## AGENDA

2. ACTION: Recommendation to review and provide direction on the Design Review and Townhouse Preliminary Plat applications for the townhouse development at 310 Georgia Road. - Associate Planner, Paige Nied

STAFF REPORT  
KETCHUM PLANNING AND ZONING COMMISSION  
REGULAR MEETING OF APRIL 15, 2026

Figure 2: Building Height Measurement

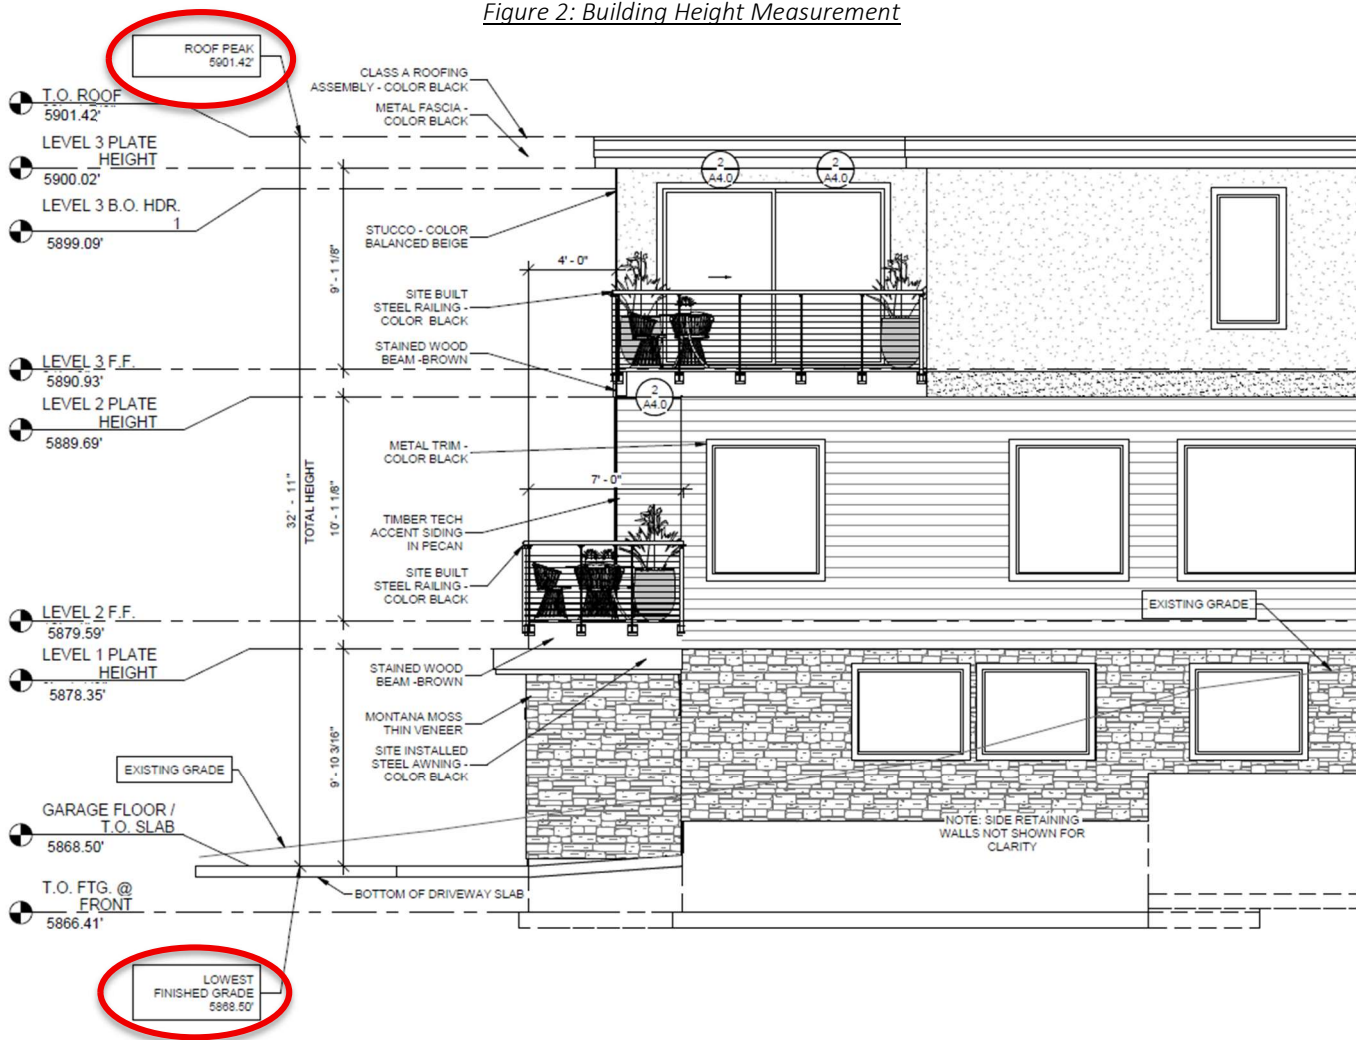
The Commission as well as public comment raised concerns regarding the accuracy of the maximum building height measurement. The Ketchum Municipal Code defines building height as:

The maximum building height is 32'-11", measured from the roof peak elevation of 5,9010.42' and the lowest finished grade elevation of 5,868.50'. The maximum building height has not changed from the previous plan set. Staff believe the concern with the building height was due to the architectural measurements and various labels of the grade on the previous plan set. The applicant revised the elevation sheets (A3.0-A3.3) to now include spot elevations, line of existing grade, and labels to identify the lowest finished grade and roof peak where the building height is measured from. Staff reviewed the building height measurements and believe the height shown on the drawings to be accurate. The building height measurement is shown in Figure 2 below from Sheet A3.1. Additionally, height certificates are required for buildings during the construction period to verify that height limits are not exceeded.

Verify the grade where the maximum building height was measured from and make it clear on the elevation sheets **On each elevation sheet, A3.0-A3.3, the total height is called out with a dimension of 32'-11" from the top of slab at driveway to top of roof, per Ketchum's Municipal Code's definition of building height that states, "The greatest vertical distance measured at any point from the roof to natural, existing, or finished grade, whichever is lowest."**

- If the building height measurement is incorrect, adjust side setbacks and building envelope as needed. **We believe the building height measurements to be correct, as we have measured from the lowest finish grade to the highest point of the roof, per Ketchum Municipal Code's definition of building height states, "The greatest vertical distance measured at any point from the roof to natural, existing, or finished grade, whichever is lowest."**

*Figure 3: Previous & Proposed Design Comparison*

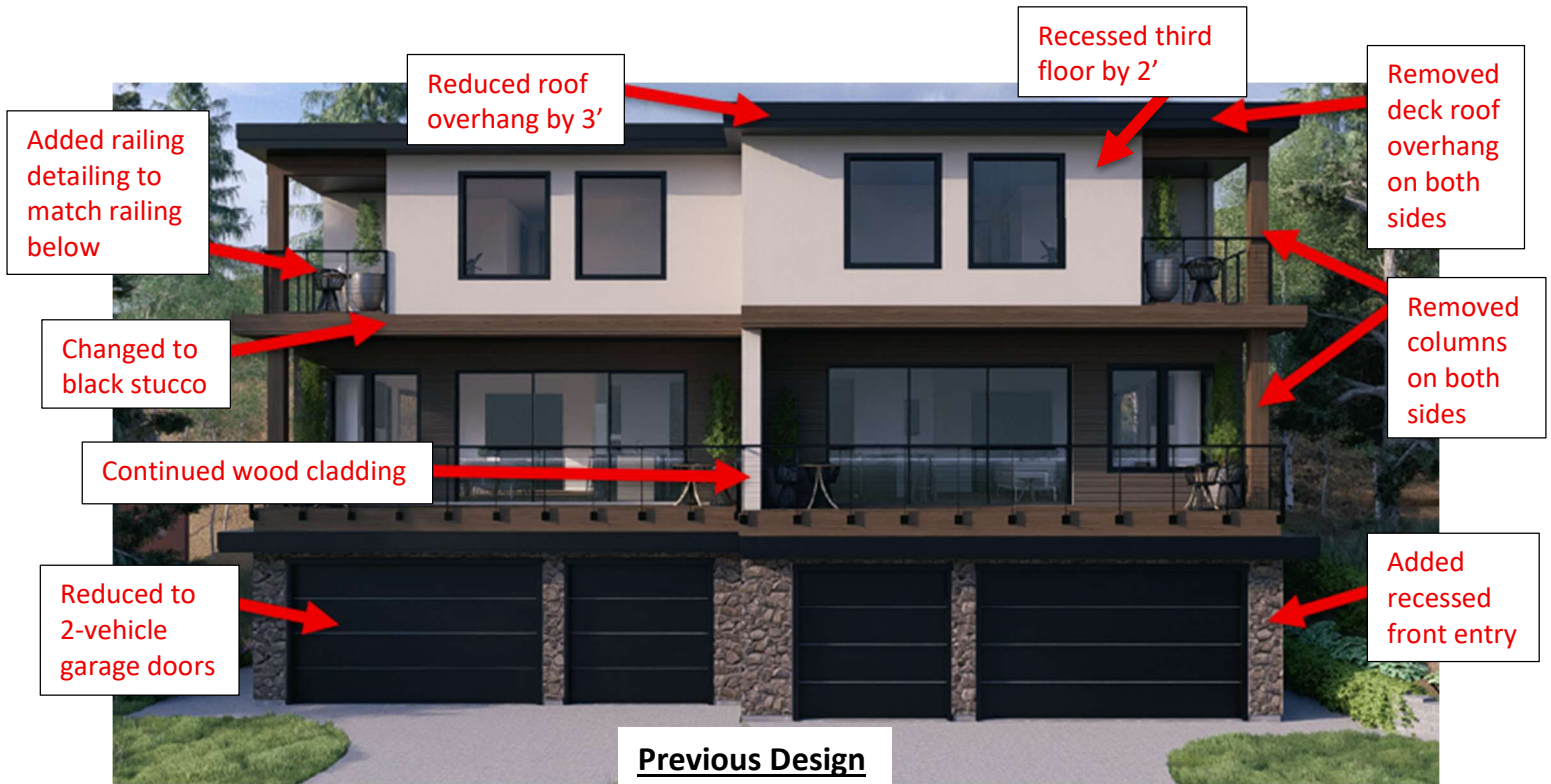
The Commission raised concerns with the perceived bulk and flatness of the structure and requested additional undulation and articulation of the façade. To achieve this, the applicant made several

modifications to the design. See Figure 3 below for an evaluation of changes to the previous design and comparison with proposed design.

Please note that the stucco color on the third floor appears darker in the rendering of the proposed design, however it has not changed and remains the color “Balanced Beige” from the previous design, which is indicated on the colors and materials sheet. Also, there was a material callout error on the elevation sheets (A3.0-A3.3) of the revised plan set, which indicates Balanced Beige as the color of the stucco belly band between the second and third floors. The applicant revised those sheets to include a red notation indicating that the correct color of the stucco belly band is Tricorn Black.

- Provide additional undulation/relief and architectural features to reducing the perceived massing of the structure. **The two ground-to-roof front columns have been eliminated by pulling the third floor back an additional two feet (five feet total**

from the garage overhang) and removing the third-floor balcony roofs. This creates additional undulation changing the roof plane and adding a new layer of visual interest. The front roof eave has also been reduced by 3' down to a 1' overhang, a stucco banding was added between level 2 and level 3 along the front and sides of the structure. The ground floor façade was broken up by reorienting the right unit entry toward the street, creating a step-back along the wall. We feel these changes helped greatly to create a more visual appealing and engaging elevation.

ROOF PLAN  
1/4" = 1'-0"

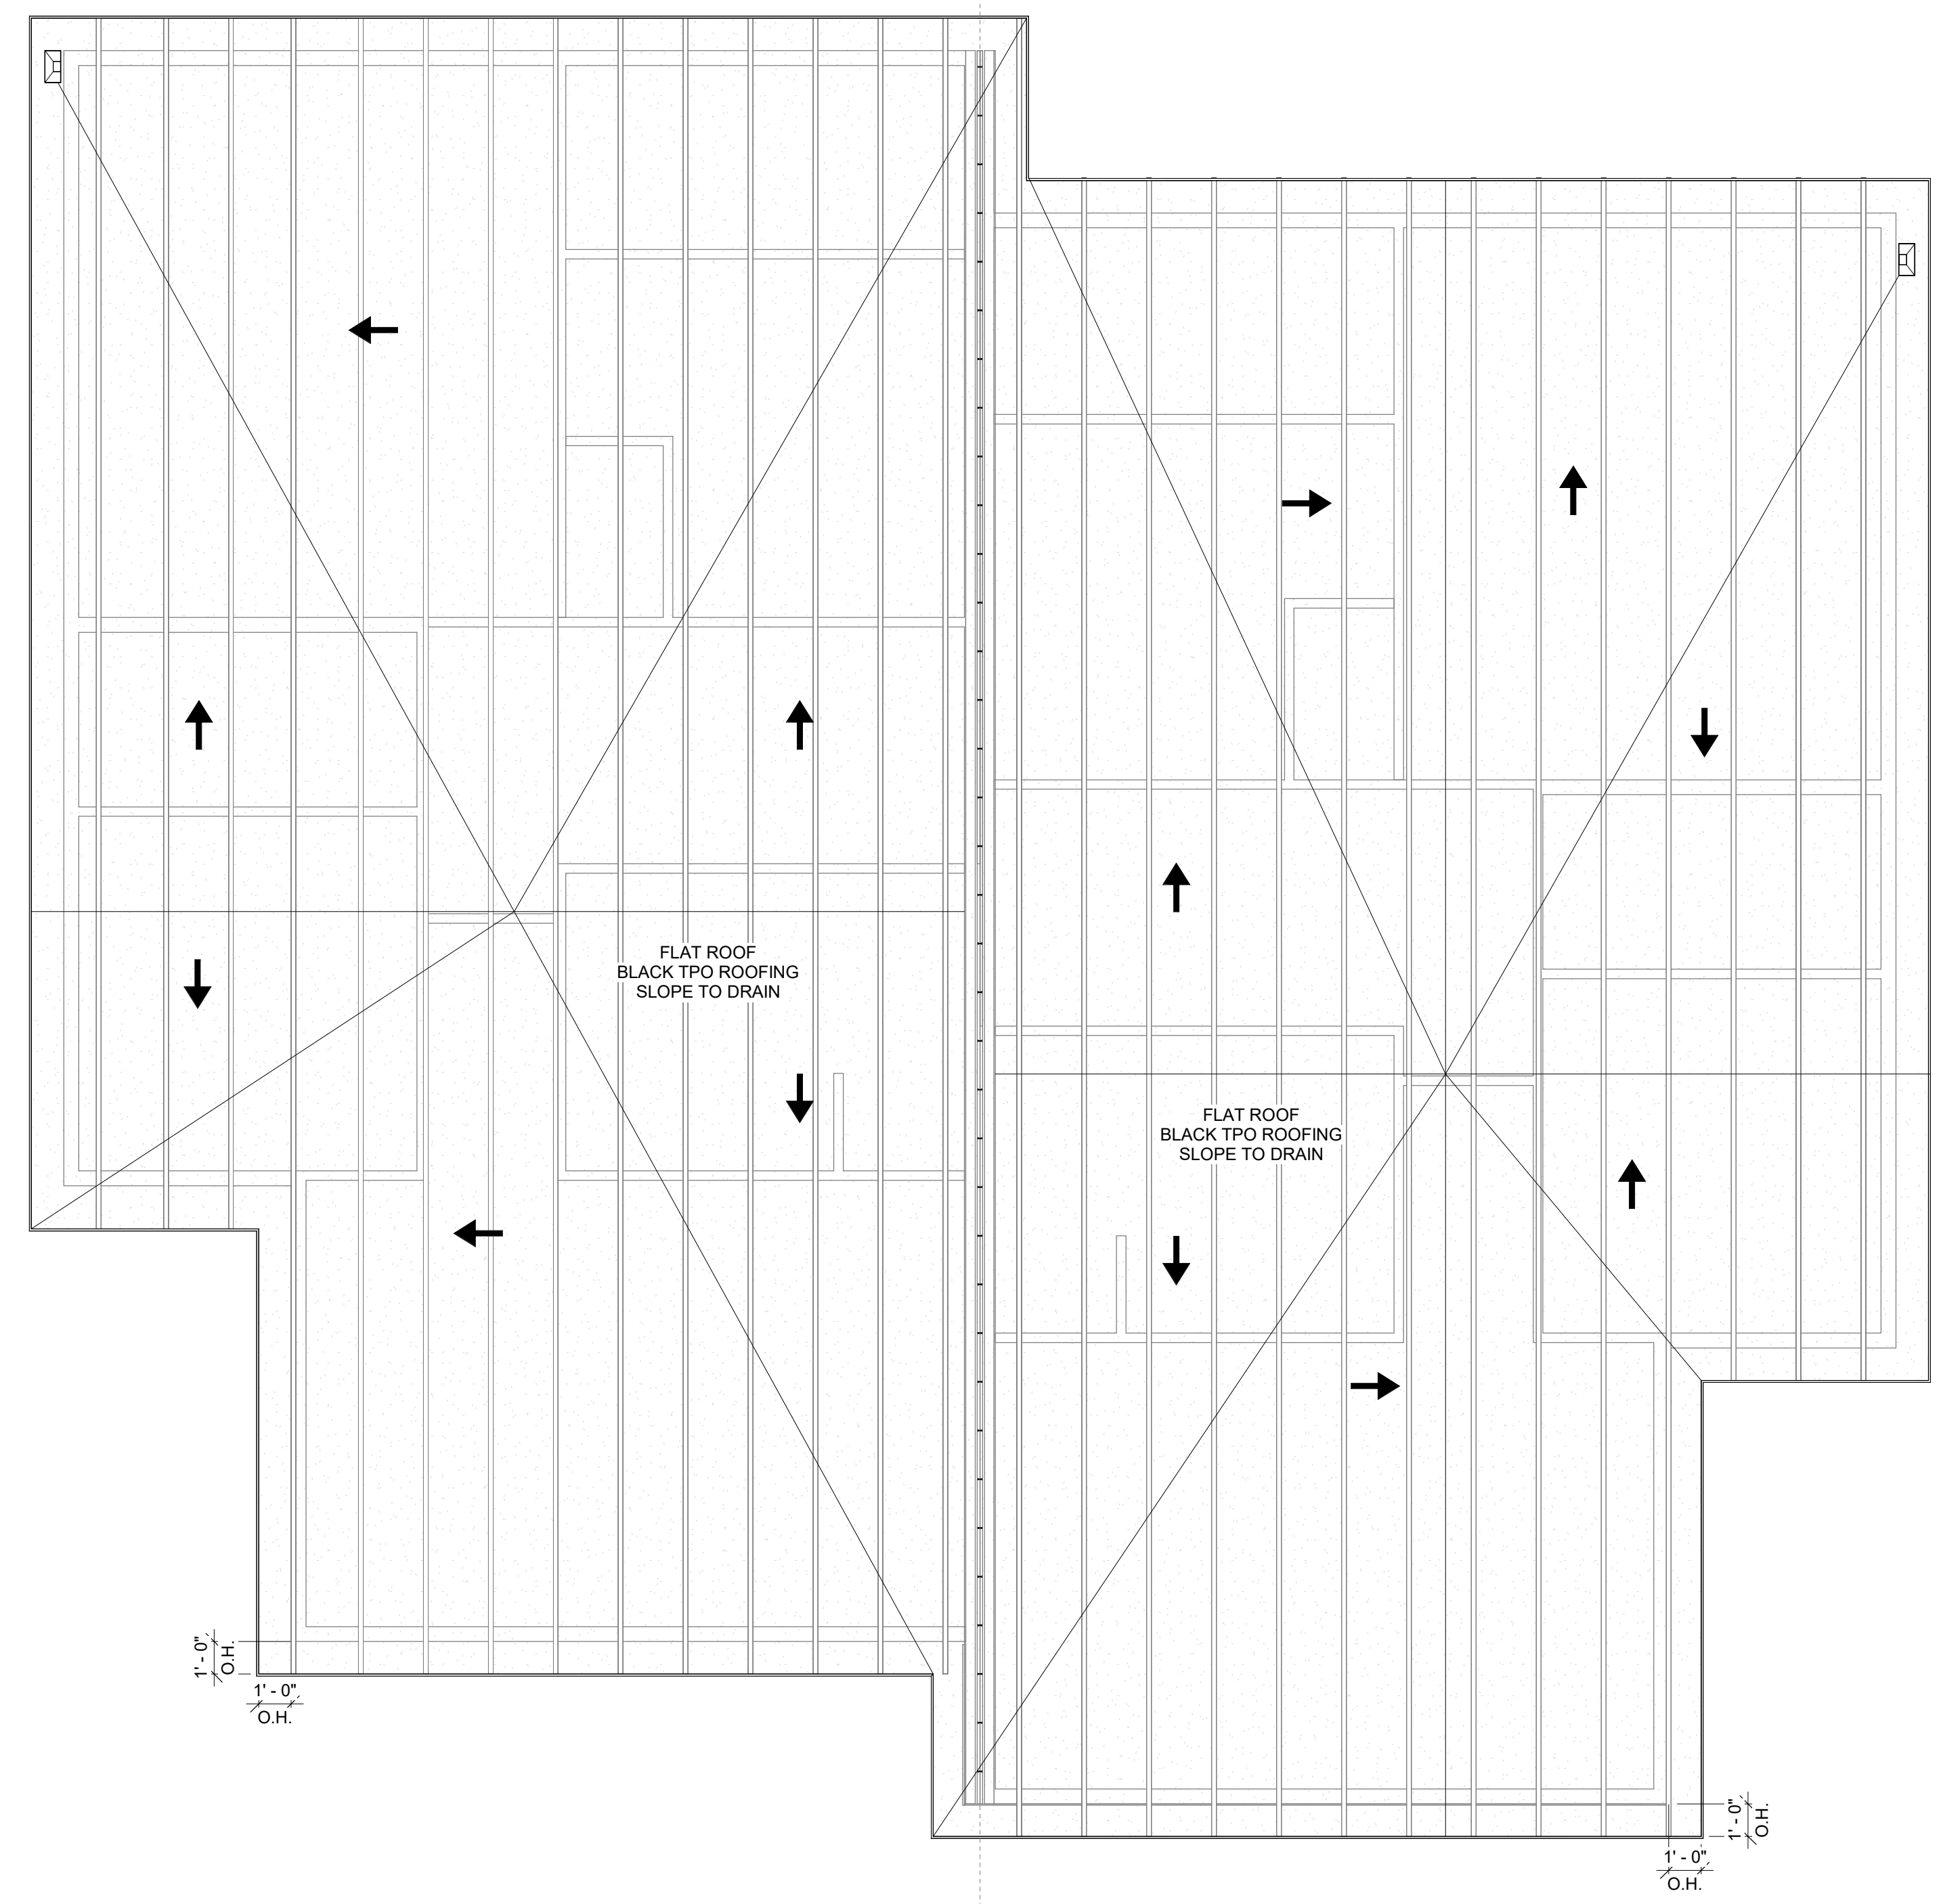
- Zoning/Dimensional
  1. Verify building height measurement
  2. Provide parking stall dimensions and improve garage access
- Design
  1. Reduce perceived bulk and flatness
  2. Improve façade articulation and side activation
  3. Reorient unit entrances towards the street
  4. Enhance compatibility with surrounding neighborhood
  5. Provide a more robust landscape plan
- Other
  1. Coordinate civil and architectural plans
  2. Indicate location and screening of AC condensers
  3. Indicate locations of downspouts on elevation sheets

- Indicate downspouts on elevation sheets. Roof drains/downspouts can be seen on sheet A5.0. They can also be seen and/or are called out on sheet A3.0-A3.3.
